## **STAFF MEMO**

**Date:** May 13, 2021  
**To:** Town of Milford Planning Board  
**From:** Jason Cleghorn, Town Planner  
**Subject:** **SP2021-15 Heritage Hill Industrial Park, LLC (owners/applicants), Map 6, Lot 33.** Major Site Plan/Conditional Use Permit application for 43,800 sf of self-storage within four (4) buildings.

**UTILITIES & LANDSCAPING PLAN**  
**TAX MAP 6 LOT 33**  
**(SAVAGE ROAD)**  
**MILFORD, NEW HAMPSHIRE**  
 PREPARED FOR:  
**HERITAGE HILL INDUSTRIAL PARK, LLC**  
 6 MANHATTAN DRIVE, AMHERST, NH 03031

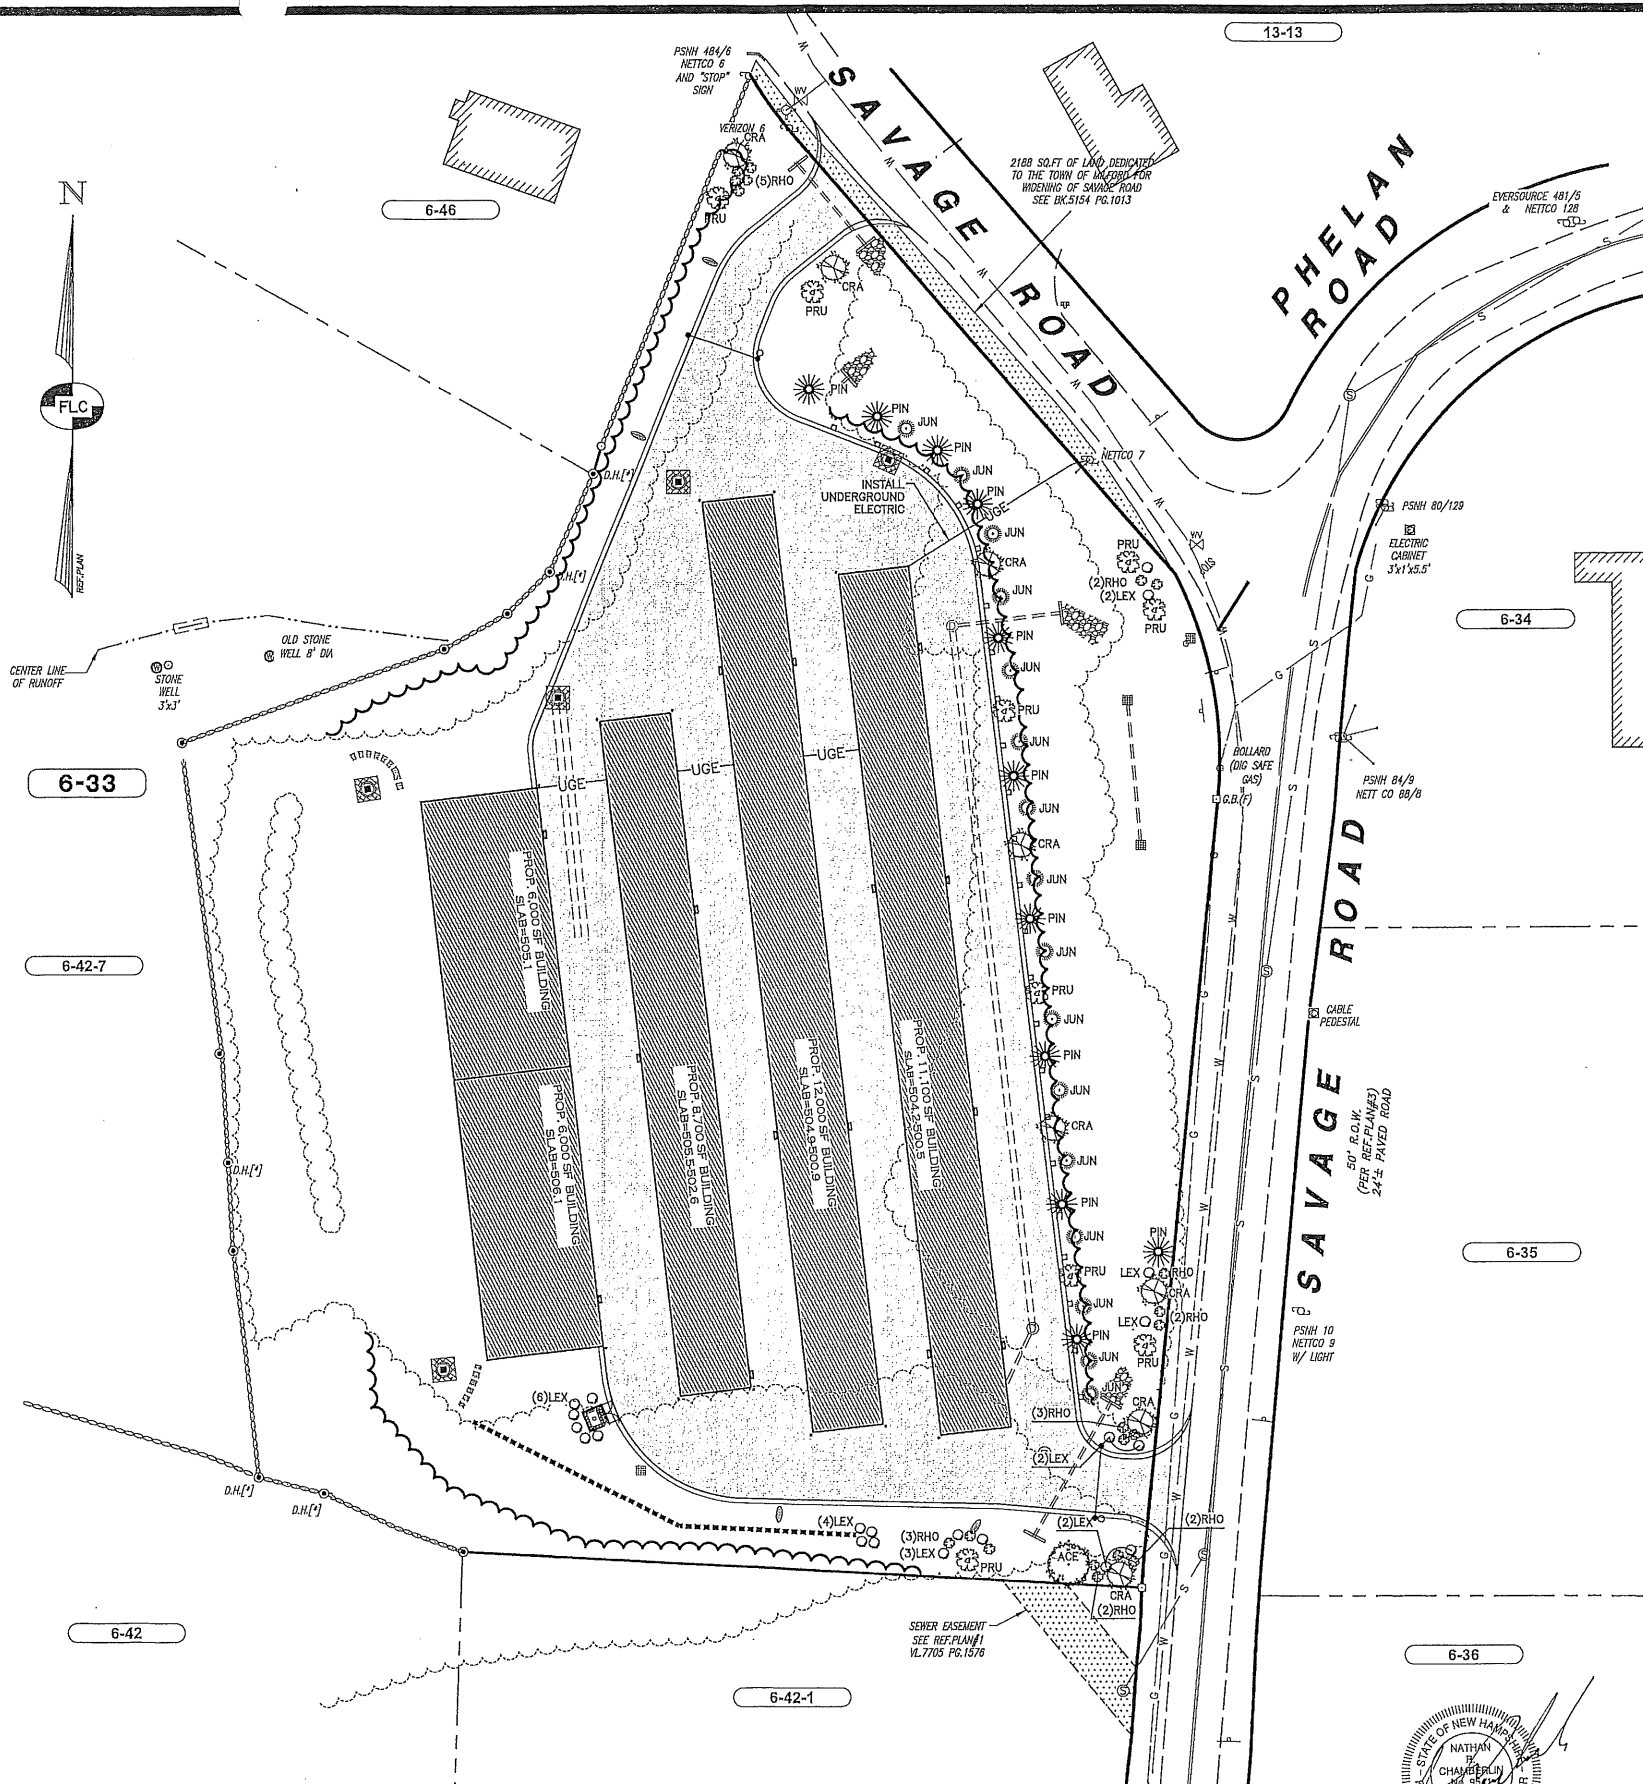
5. Note 3 on Page 2 of 8 needs to be revised to reflect the correct Open Space amount.
6. A ten foot buffer is required adjacent to Parcel 6-46 along the NW border. How much of the existing vegetation will remain? Add a note about retained vegetation and trees and tabulate.

# **DUMPSTER AREA DETAIL**

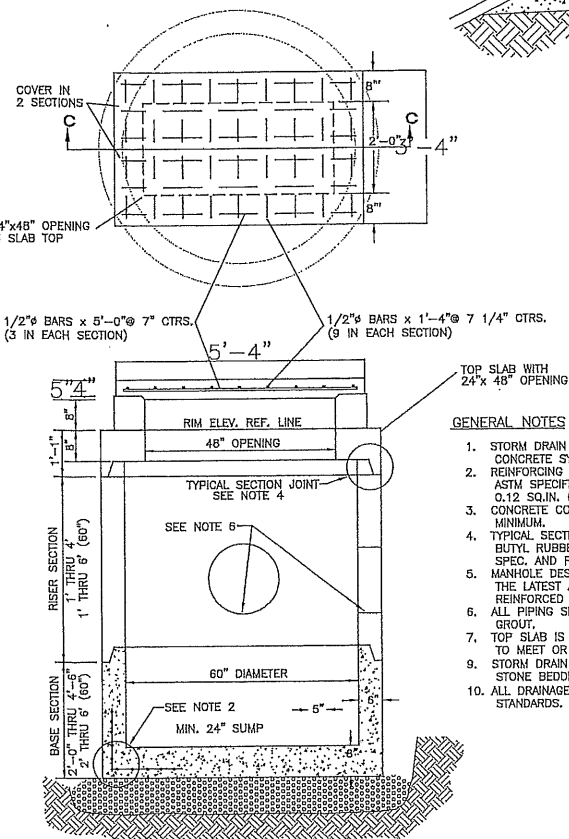
1. Add the Planning Board signature block to the cover page.
2. Modify Proposed Note F to refer to Section 6.06 of the Milford Development Regulations.
3. Regarding Note J of the Proposed Notes, the location of the dumpster. Please designate the location of any dumpsters on the Site Plan, and if they already are, but Staff couldn't determine, label them. Add a standard detail for the dumpster screening.
